IEEE P802.15 Wireless Personal Area Networks

Project	IEEE P802.15 Working Group for Wireless Personal Area Networks (WPANs)	
Title	TG3 LB19 comment resolution	
Date Submitted	[12 September, 2002]	
Source	[James P. K. Gilb] [Apparent Technologies] [9921 Carmel Mountain Rd. #247, San Diego, CA 92129]	Voice: [858-538-3903] Fax: [858-538-3903] E-mail: [gilb@ieee.org]
Re:	[]	
Abstract	[This document is a record of comment resolutions for LB19.]	
Purpose	[To provide a record of the comment resolution for LB19.]	
Notice	This document has been prepared to assist the IEEE P802.15. It is offered as a basis for discussion and is not binding on the contributing individual(s) or organization(s). The material in this document is subject to change in form and content after further study. The contributor(s) reserve(s) the right to add, amend or withdraw material contained herein.	
Release	The contributor acknowledges and accepts that this contribution becomes the property of IEEE and may be made publicly available by P802.15.

1. Conference calls

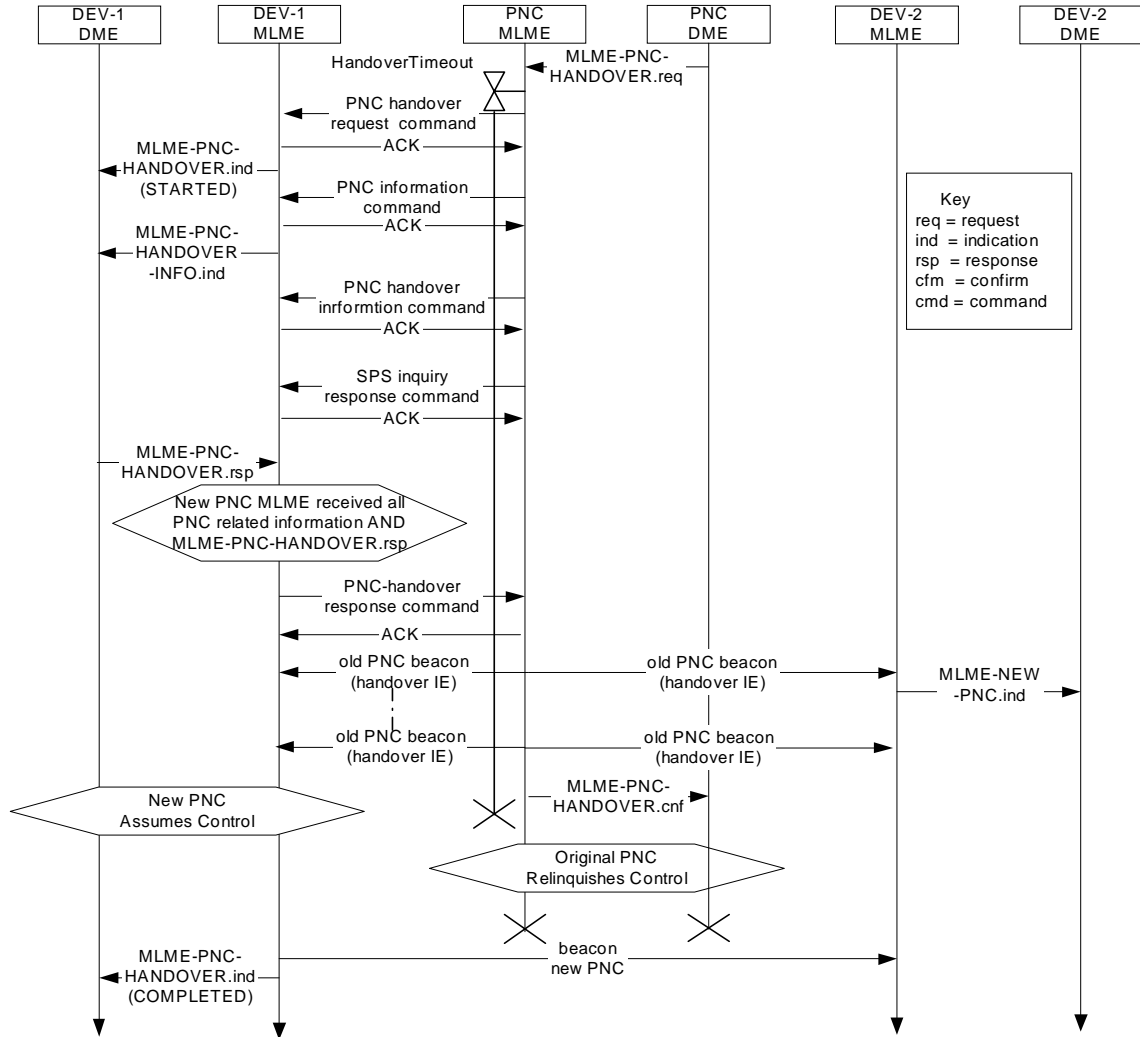
269 (Heberling, TR) - [PNCHndOvr] Some errors in text remain or were introduced after LB17.MSC in Figure 91 is also wrong./KO Text changes for 8.2.3 and ne MSC for Figure 91 are all collected in:02276r7P802-15_TG3-commentsD11_KO.doc, Resolution [03]. **Suggest accept in principle**, “The MSC will be modified as indicated in the resolutions of CID 58 and 232. Make the following text changes: In 6.3.13.4, page 59, line 45, change ‘This primitive informs the originating DME its request for information from the PNC is complete.’ to be ‘This primitive informs the DME that the MLME has received a PNC information command, {xref 7.5.4.2}.’ In 7.5.3.1, page 138, line 20 ‘the number of information records to be transferred using the PNC information command frame(s).’ to be ‘the number of DEV information records, {xref PNC handover info command}, that will be transfered from the old PNC to the new PNC.’ In 8.2.3 PNC Handover, delete page 156, line 8-9, redundant, same text in paragraph below. Add to page 156, line 19, ‘The PNC handover information command shall not be sent if the PNC has indicated in the PNC handover request command that it does not have any CTRBs to transfer.

The SPS inquiry response command shall not be sent if the PNC has indicated in the PNC handover request command that it doesn’t have any SPS sets to transfer.’

Add to page 156, line 35, ‘The new PNC shall broadcast its first beacon at the time the beacon would have been sent by the old PNC. This time may vary from the actual time due to clock inaccuracies of old and new PNCs. The new PNC shall start sending beacons with the beacon number counter set to one more than the beacon number of the last beacon that will be sent by the old PNC.’

Add page 156, line 40ff, ‘The PNC shall ensure that the beacon countdown includes at least one system wake beacon and at least aMaxLostBeacons beacons following that system wake beacon. The only exception to this requirement is if the PNC will be shutting down and does not have enough time to to wait for the next system wake beacon to complete the handover process. {Ed. note: This line may be moved to a new 8.1.1 that describes all beacon announcements.’ }

The parent PNC shall not hand over to a DEV that is currently operating as a dependent PNC.’”

Figure 1—PNC handover MSC

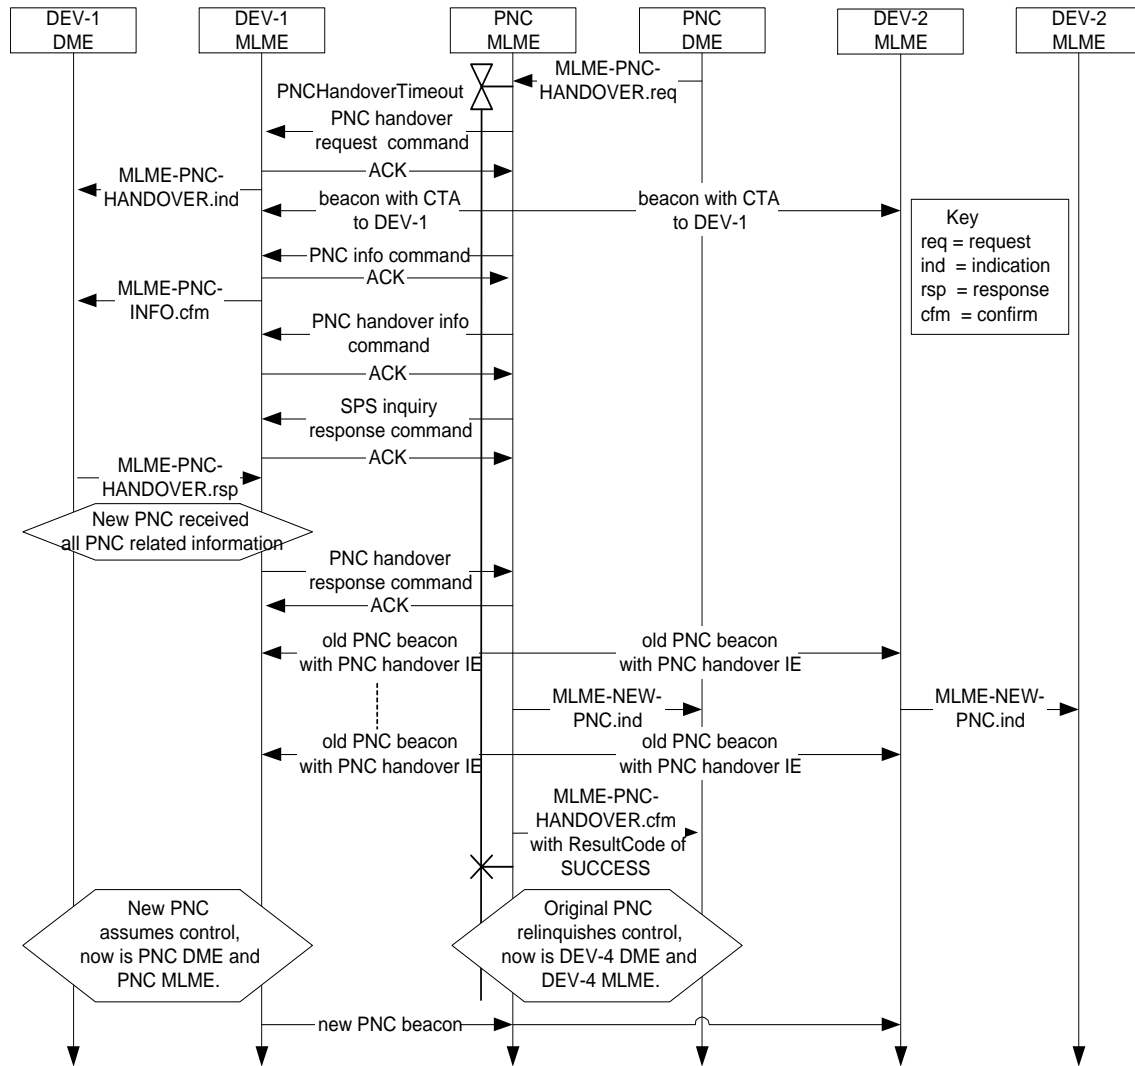
463 (Gubbi, TR) - Figure-91 is a well done job, but the text needs to supplement some info that can not be expressed in the figure, which is incomplete in the current update to this para. It should be mentioned that these commands shall be sent by PNC even if there is no information present that fits into those commands so that the rx-DEV knows the exact end of the transaction. For example, what if there are no DEVs in power save mode. Still the SPS-inquiry-response-command shall be sent by PNC. It should be mentioned that the three commands in Figure-91 (PNC-info-command, PNC-handover-info-command and SPS-inquiry-response-cmd) shall be sent by PNC even if there is no information present that fits into those commands so that the rx-DEV knows the exact end of the transaction. For example, what if there are no DEVs in power save mode. Still the SPS-inquiry-response-command shall be sent by PNC. **Suggest accept in principle.** "Rather than send the empty commands, the PNC handover request will contain the number of CTRBs and SPS sets that will be transferred. If the number of items is zero, then the old PNC shall not send the command and the new PNC will not expect to receive it. It is not possible for the number of DEVs to be less than 2 (i.e. the old PNC and the new PNC), so the PNC information command will always be sent. This is documented in the resolution of CID 269."
